SUBJECT: Contract 008066  
SR 520 Floating Bridge and Landings Project  
Federal Aid No.: BR-0520(047)  
Change Order No. 068 – FA-Additional Underwater Inspection & Design

CONTRACT NO: 008066 FEDERAL AID NO: BR-0520 (047)  
 CONTRACT TITLE: SR 520 / I-5 TO MEDINA - EVERGREEN POINT FLOATING  
 CHANGE ORDER NO: 68 FA-ADDTL UNDRWIR INSP & DGN

CHANGE ORDER NO: 68

### "W" PONTOON

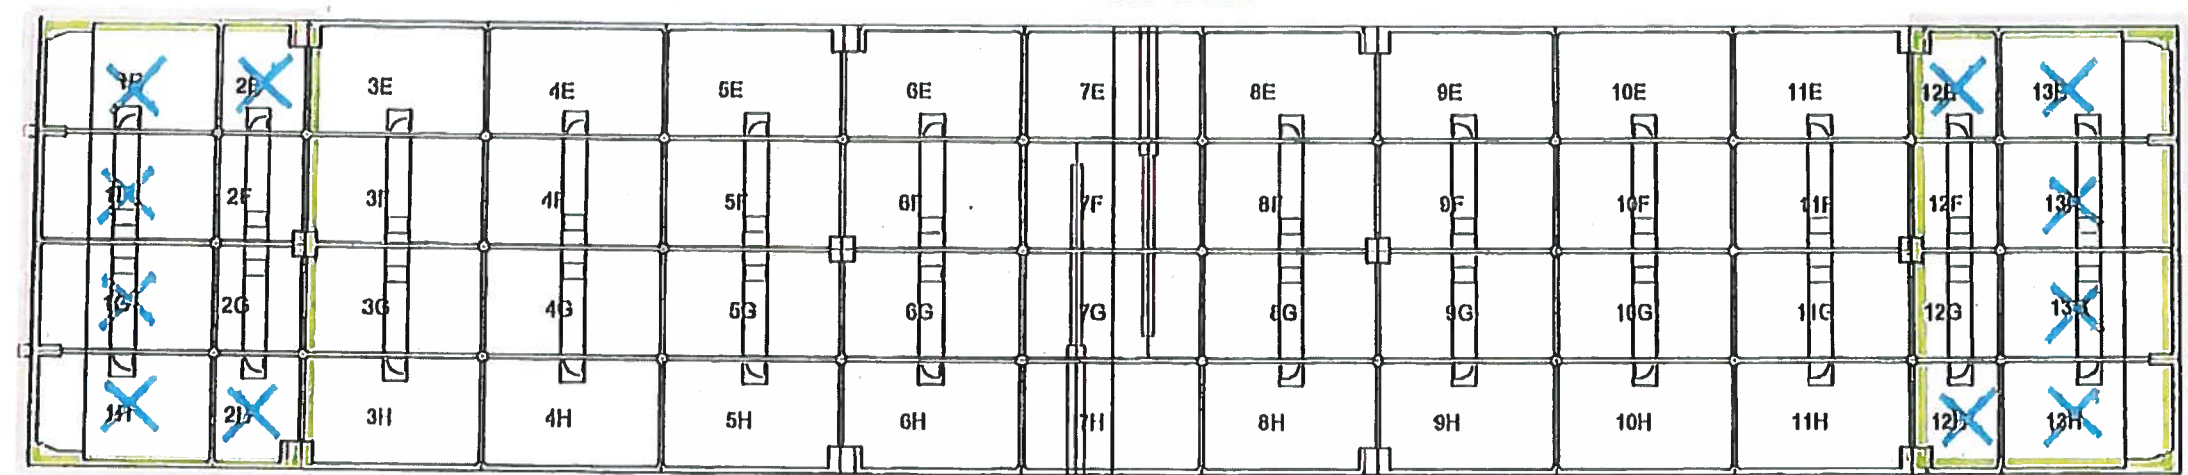
\* Exterior crack mapping for Pontoon W shall also include the keel slab and exterior walls of the area shown on 6 of 7 of 008066 Change Order No. 068."

Limits of underwater keel slab and exterior wall inspection
